DESIGN <i>[Signature]</i>	DRAWN BY <i>[Signature]</i>	<b>DART AEROSPACE LTD</b> HAWKESBURY, ONTARIO, CANADA	
CHECKED <i>[Signature]</i>	APPROVED <i>[Signature]</i>	DRAWING NO. <b>DSI 9370</b>	REV. A SHEET 1 OF 1
DATE <b>07.02.27</b>		TITLE <b>PLACARD REPLACEMENT</b>	SCALE NTS
REV A	DATE 07.02.27	DESCRIPTION NEW ISSUE

## **DART SERVICE INSTRUCTION**

**FIGURE 1: PARTIAL REMOVAL OF D2258-XXX PLACARD**

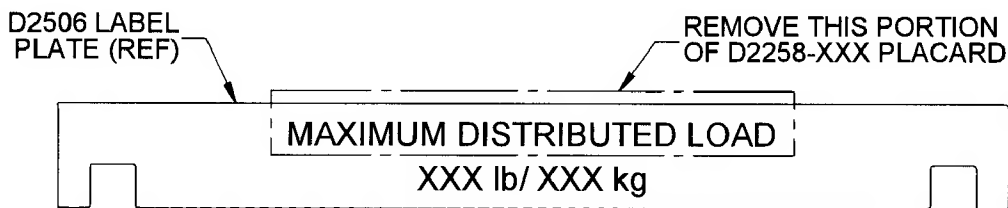
When the D350-607-XXX and D130-701-XXX Heli-Utility Baskets are installed on a Brazilian registered aircraft, replace a portion of the D2258-XXX Placard located on the D2506 Label Plate on the Basket Lid with D3605-1 Placard as follows:

1. Remove letters as indicated in Figure 1 below by lifting the edge and carefully peeling each letters at an angle of 90 to 180 degrees. Speed and angle of removal may affect amount of residue and the amount of paint removed.
2. Remove adhesive residue using 4105S Wash 'n' Wipe Degreaser or MEK (or equivalent). Scrape softened adhesive off surface using a plastic squeegee. Repeat if required.
3. Saturate a clean cotton cloth with 4105S Wash 'n' Wipe Degreaser or MEK (or equivalent) and wipe the surface to clean the entire area.
4. If necessary, touch up paint in accordance with relevant ICA (ICA-D350-607 or ICA-D130-701).
5. Install D3605-1 Label per Figure 2 using a 3M PA-1 Plastic Applicator (or equivalent) to work out blisters as required.
